AGENDA
City of Gig Harbor Design Review Board
Virtual Meeting of August 11, 2022 at 5:00 pm

**PLANNING DEPARTMENT
STAFF REPORT**

RE: The Reserve Preliminary Plat (PL-DR-22-0005, PL-PPLAT-22-0001, PL-ALP-22-0001, PL-SEPA-22-0004)

DRAWING
C1.00

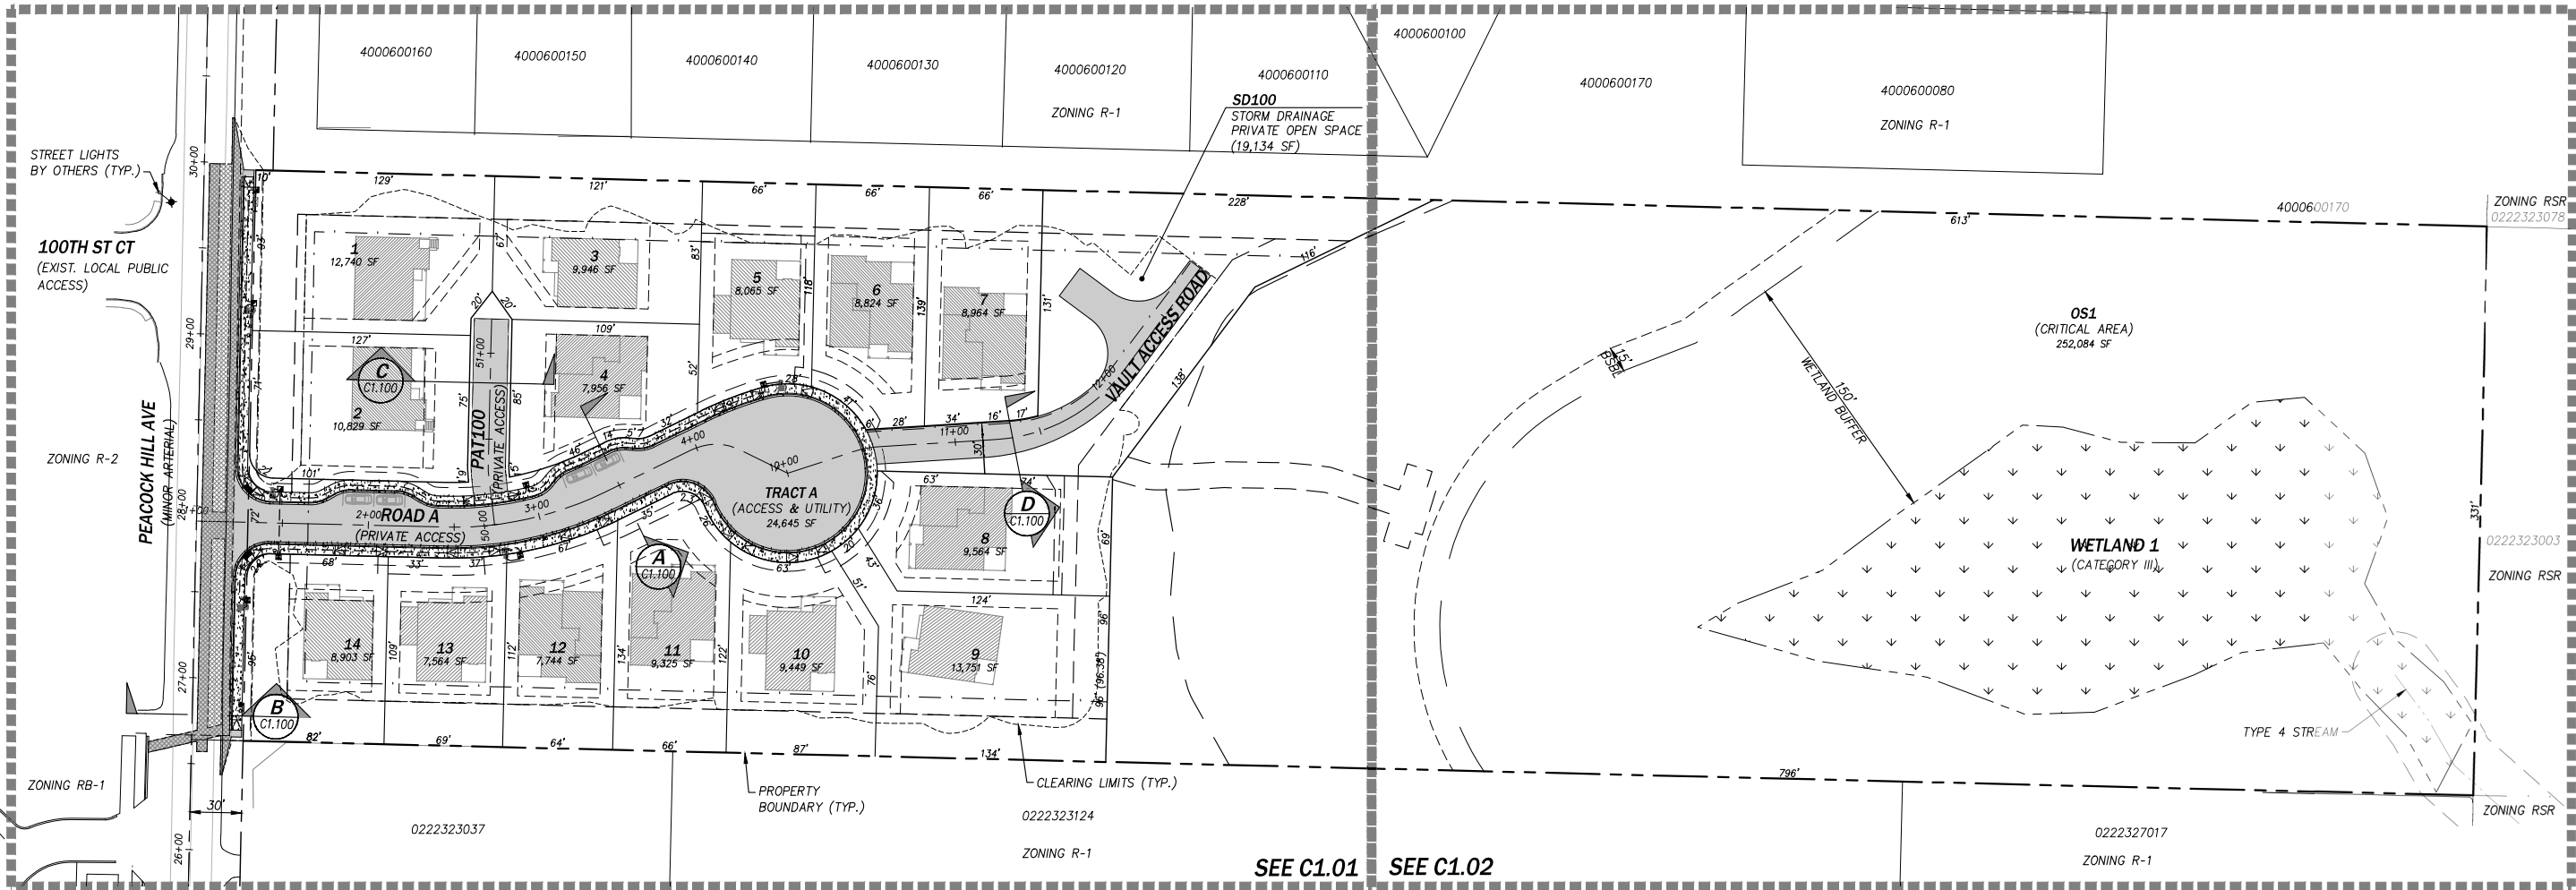
- 1. Applicant's request:** The applicant is requesting a deviation from the requirement to balance cut and fill across a project site. Relief from the strict requirement limiting retaining walls to six feet in height is also requested for two 6.1 to 15.1-foot walls along the north and east elevations of the storm drainage vault.
- 2. Staff analysis:** The intent of GHMC 17.99.240 is to ensure sites preserve the natural topography within the final development and avoid levelling sites. The site has challenging topography, and slopes east from Peacock Hill Avenue at an approximately 15% grade, but slopes on the western portion of the site vary up to 30%. The development is taking place in the western portion of the site, and much of the fill is required in the eastern portion of the development area.

Engineering requirements for the construction of a residential access road require the road be no steeper than 15%. Maintaining this 15% grade on this slope with minimal cut and fill prompted the applicant to submit for two public works variances, reducing the length of the road, as the eastern portion of the site is much steeper. The cul-de-sac and stormwater vault require a significant amount of fill as well as the use of retaining walls above the six foot height requirement.

The proposed grading scheme is outlined on sheet C1.00 of Exhibit A and utilizes 23,640 cubic yards of import fill and 5,341 cubic yards of cut to accomplish the development, a net 18,307 cubic yards of import fill. The project will also utilize a series of fifteen retaining walls as detailed on sheet C3.00 of Exhibit A. The retaining walls, except for those around the stormwater vault, are proposed to be terraced and vegetated to reduce their visual impact throughout the development and conform to the strict requirement of six foot height. The walls will be constructed from mechanically stabilized earth, with a geogrid in the lower section. The walls will be freestanding and not tied together.

The walls which exceed the six foot height requirement are around the stormwater vault in the northern portion of the development. The northeast wall of the vault begins at 6.1 feet in height and rises to 12.3 feet; the southeast wall of the vault begins at 12.3 feet in height and rises to 15.1 feet. The northeast wall faces a residential subdivision to the north but will be obscured by at least 50 feet of vegetated buffer (25 feet on both sides of the property line). The southeast wall faces the open space and critical area tract (Tract OS1) and will not be visible from within or outside the development.

3. **Findings:** DRB finds the proposed design alternative for the Reserve meets the intent of the general requirement and is equivalent to the specific language because the proposed topography maintains the general grade of the site. The size and placement of the proposed walls, in addition to their design, will minimize their potential for visual impacts.
4. **Recommendation:** The Design Review Board recommends the Hearing Examiner approve the proposed grading plan including the importation of fill exceeding the cut amount leading to an imbalanced earthwork, as well as retaining walls exceeding six feet.
